January 17, 2022

Our Project No.: AA16-190B

**Re: 35, 40 & 55 Silvercreek Parkway South
Scoped EIS Addendum Report**

NATURAL FEATURES AND ASSOCIATED BUFFERS

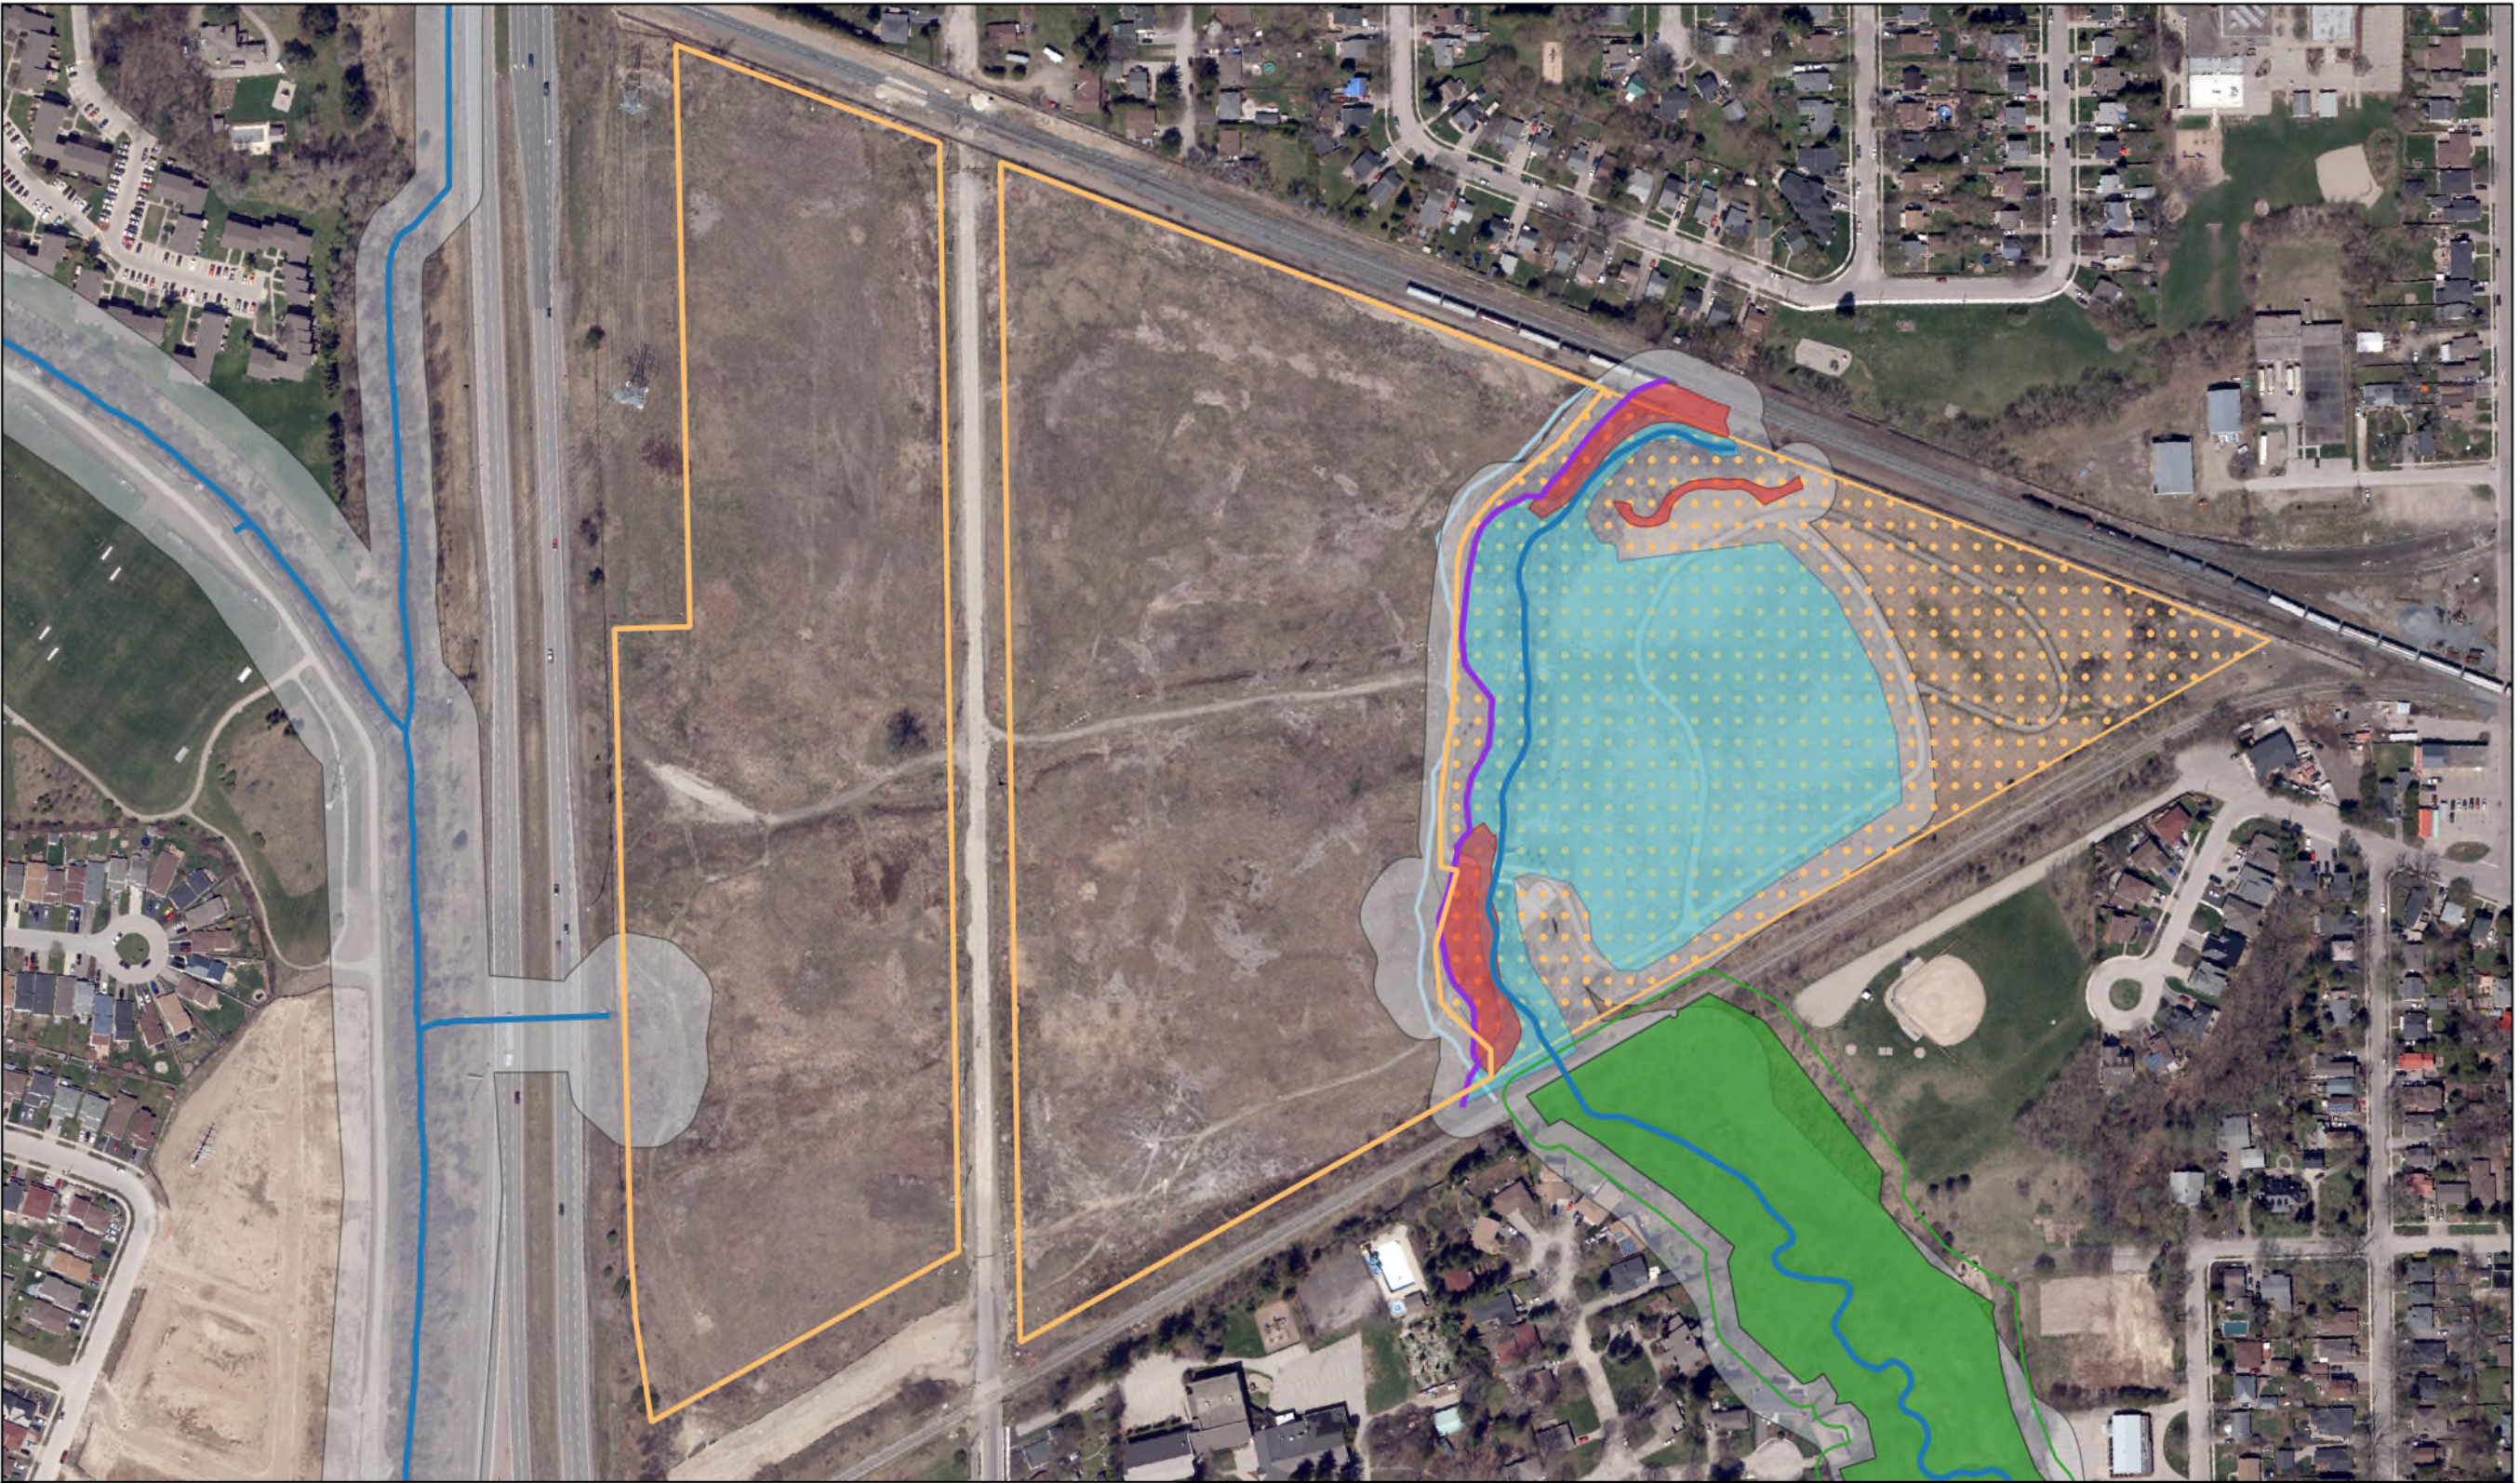
Please clarify the revised Significant Valley land limit on a map. Figure one shows components but is unclear as to the feature limit.”

"Please provide one map that shows the confirmed limits for all of the natural heritage features and areas, along with their buffers. This map should represent the final/protected NHS proposed through the application."

Figure 1 has been revised to include the Significant Valleyland Limit and its components.

Figure 1 provides the confirmed limits for all the natural heritage features and areas as well as their respective buffers.

Tree Inventory and Preservation Plan

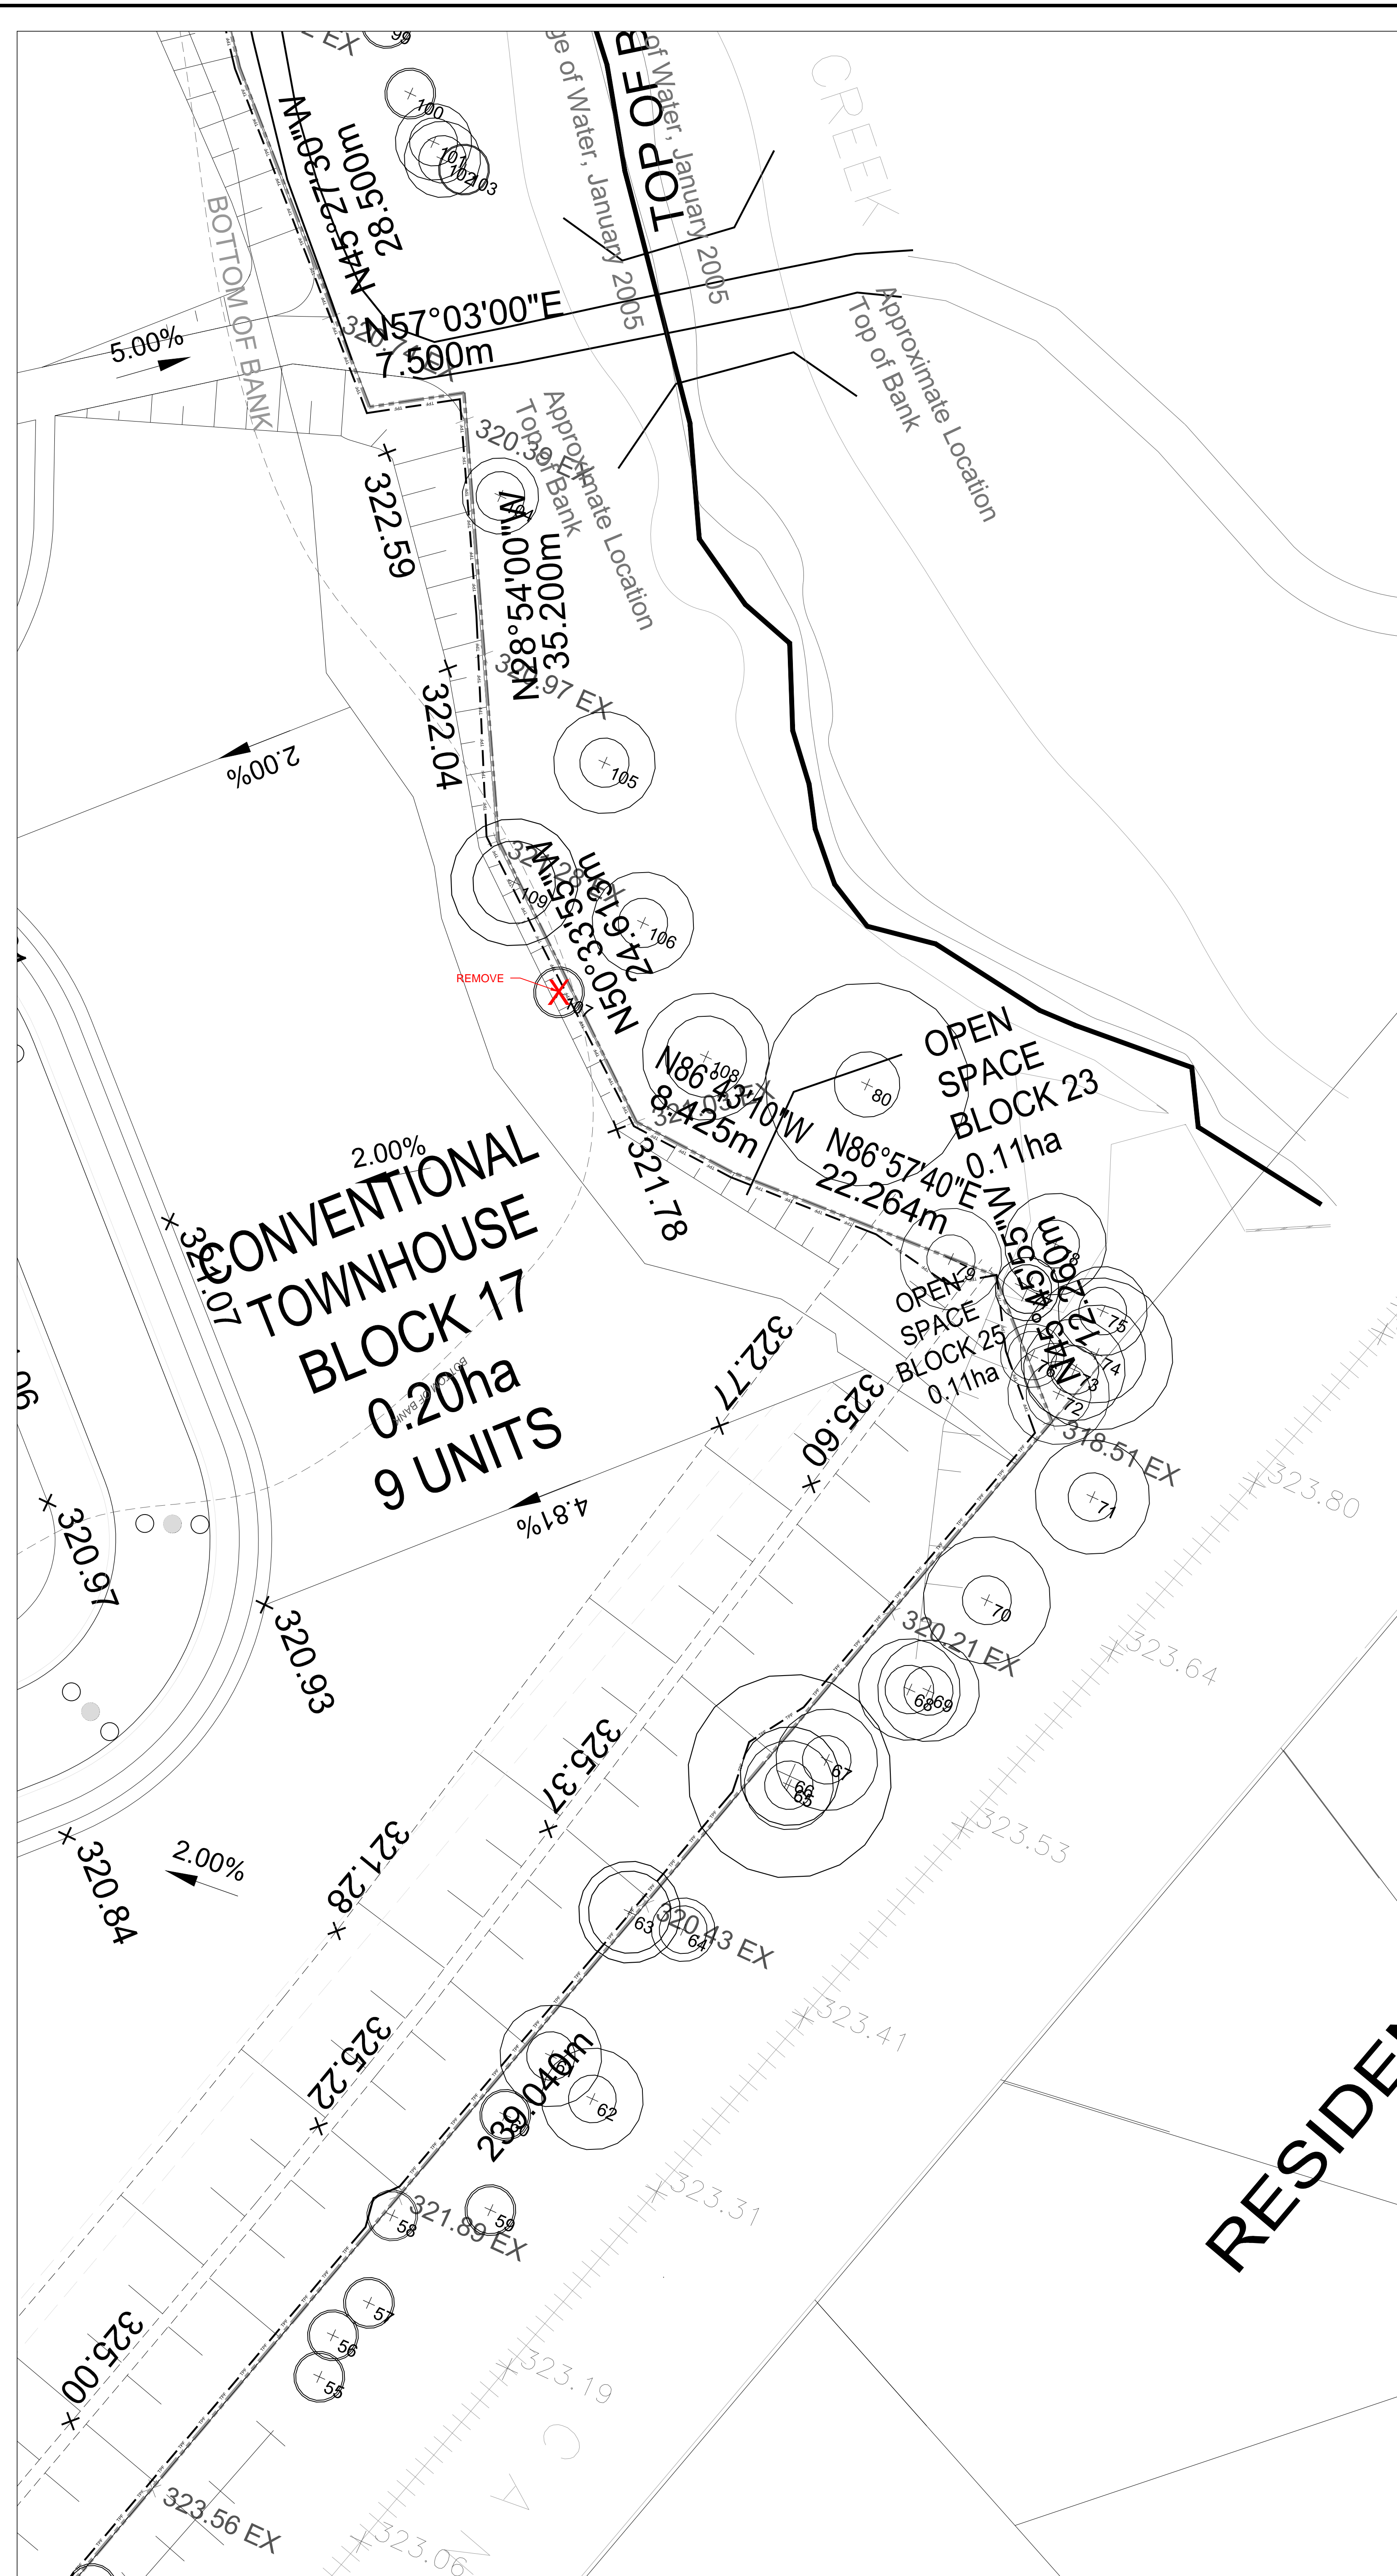
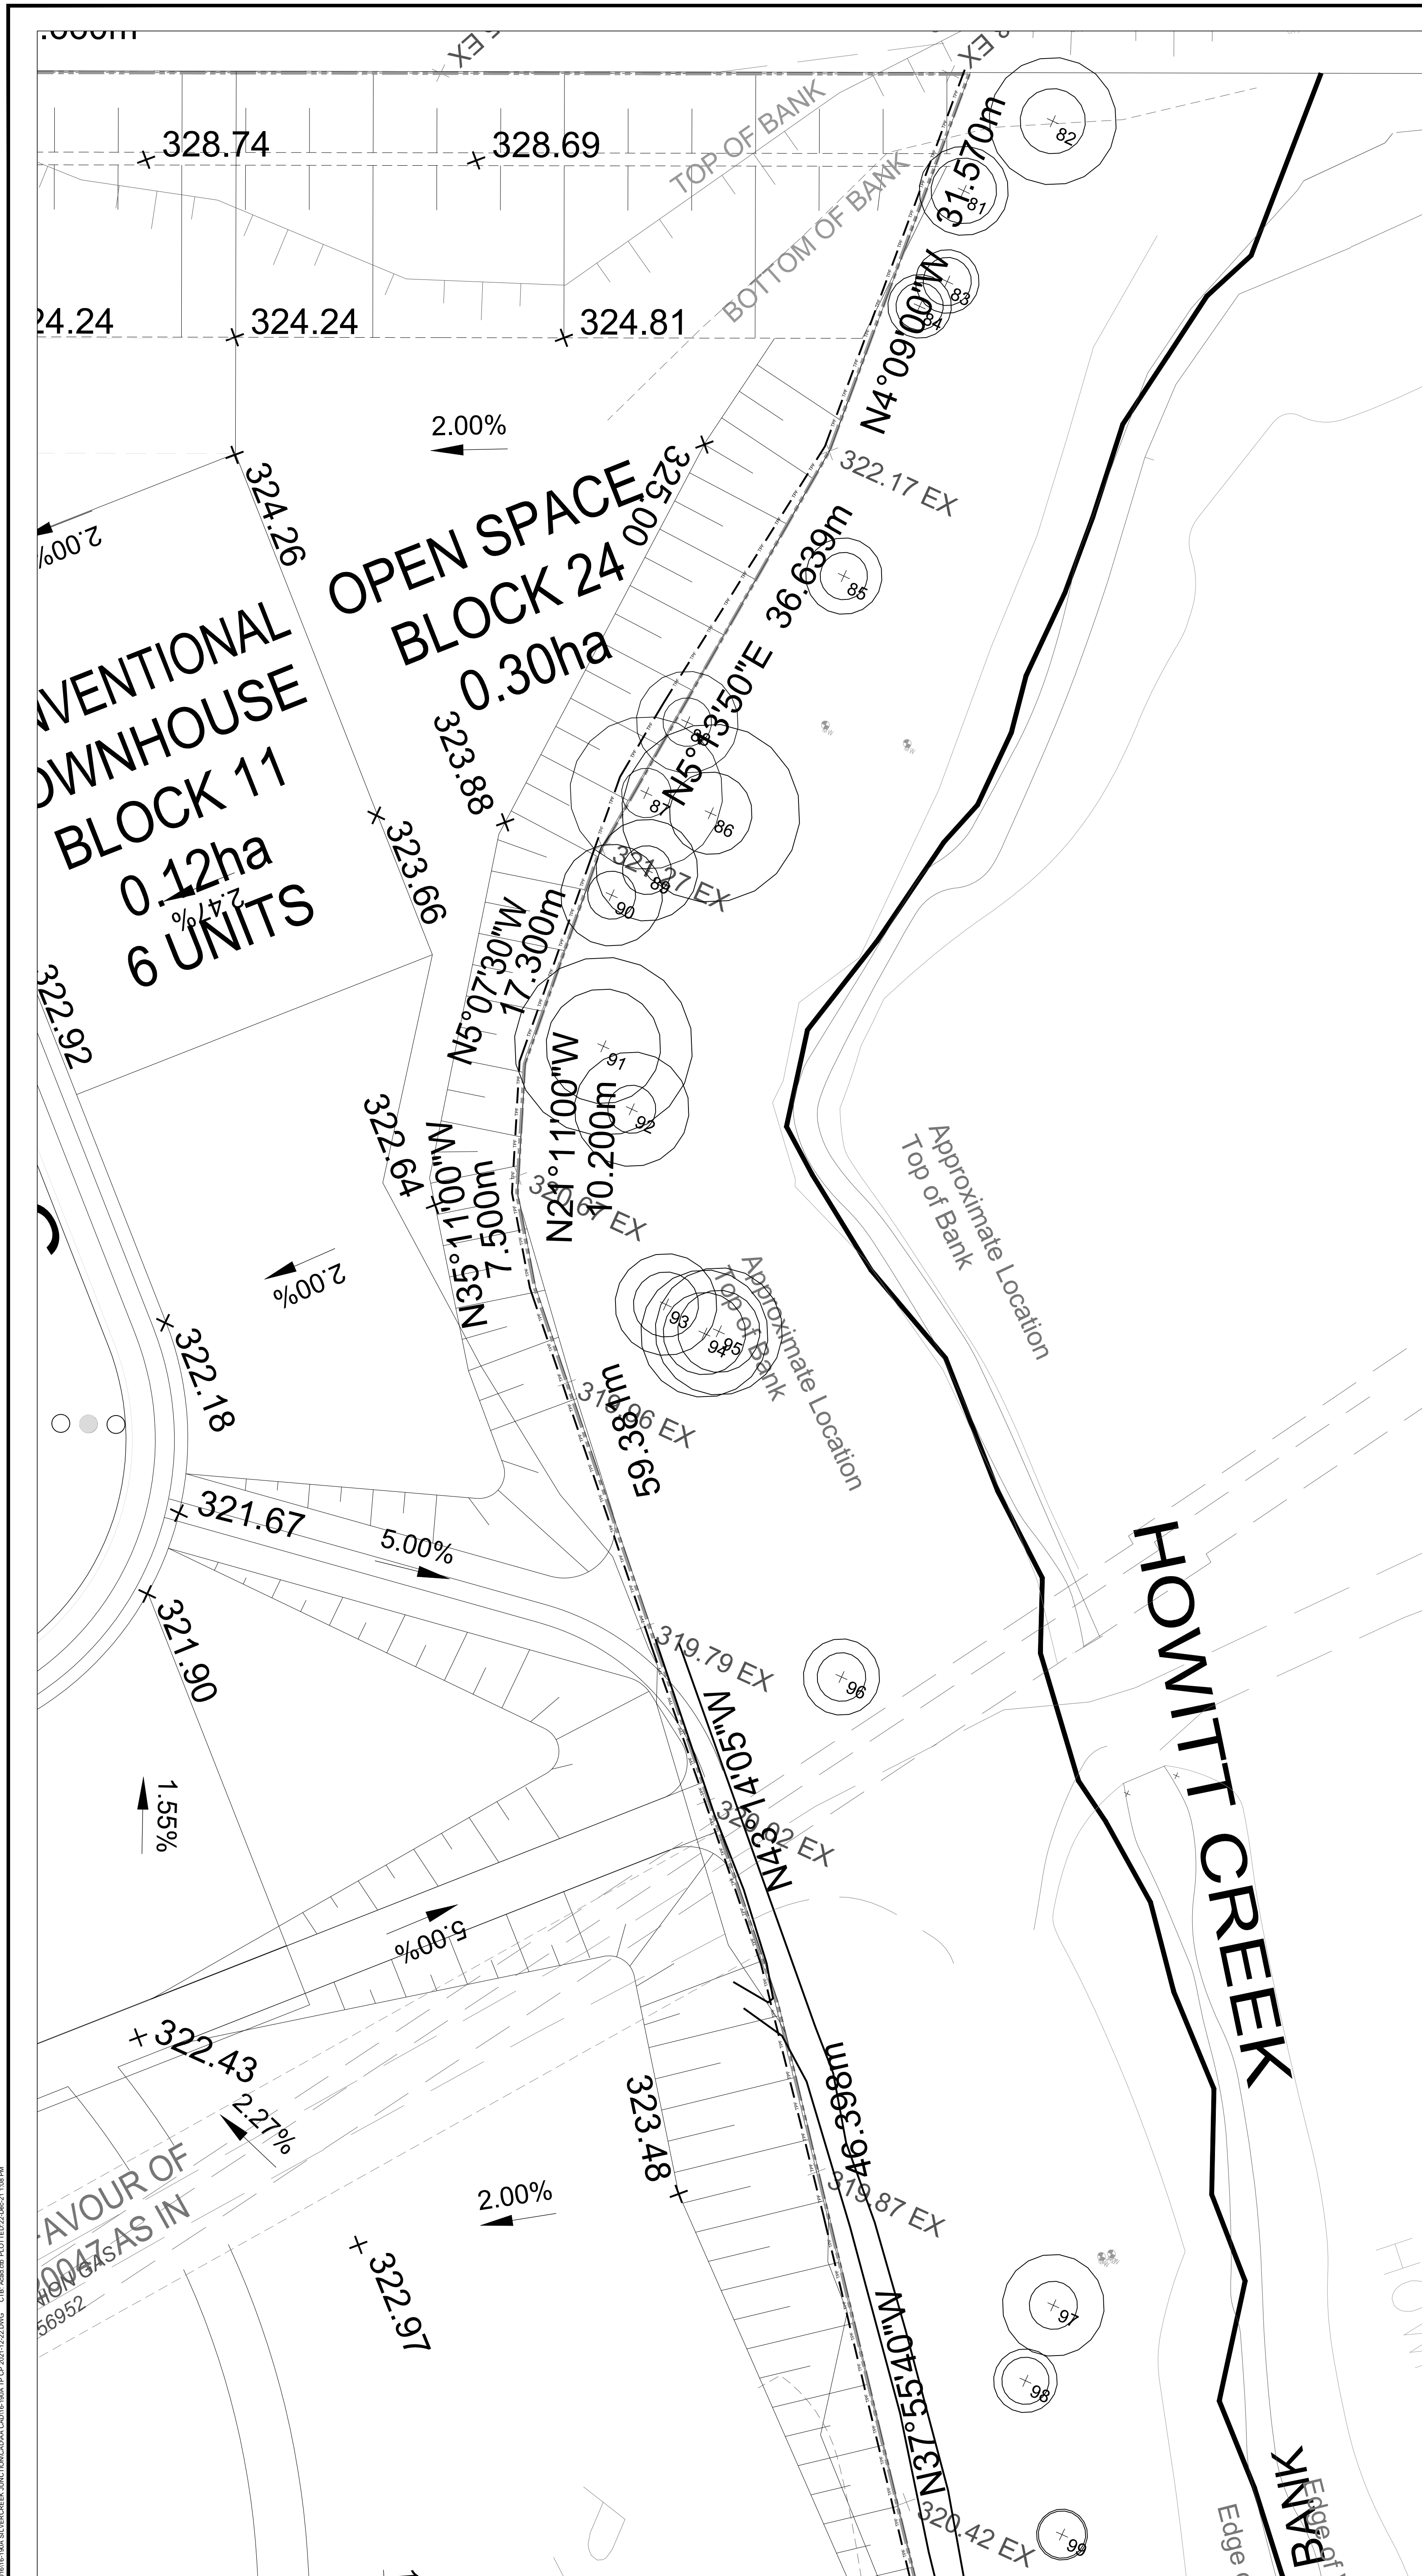
“Per the submitted tree plan and as discussed in Section 4.2 of the EIS Staff acknowledge the new/additional tree removals are required because of the acquisition of the adjacent property, and that the current plan proposes to use this area for a combination of SWM and an apartment block. Please confirm how many trees are being proposed for removal. TP3 shows 11 (which corresponds with the 125mm tree caliper compensation note on TP4), but the tree table includes 19 recommended for removal- including some shared ownership trees. Do these other 7 trees warrant discussion with the City regarding their removal? Please clarify.”

The Tree Preservation Plan (*Appendix 1*) has been updated to clarify the recommendations regarding offsite and share trees in poor or dead condition. Trees that will not be affected by the work are either boundary or offsite should be retained and managed at the owner's discretion. The updated plan will show 11 trees to be removed due to development, 9 of which will require compensation.
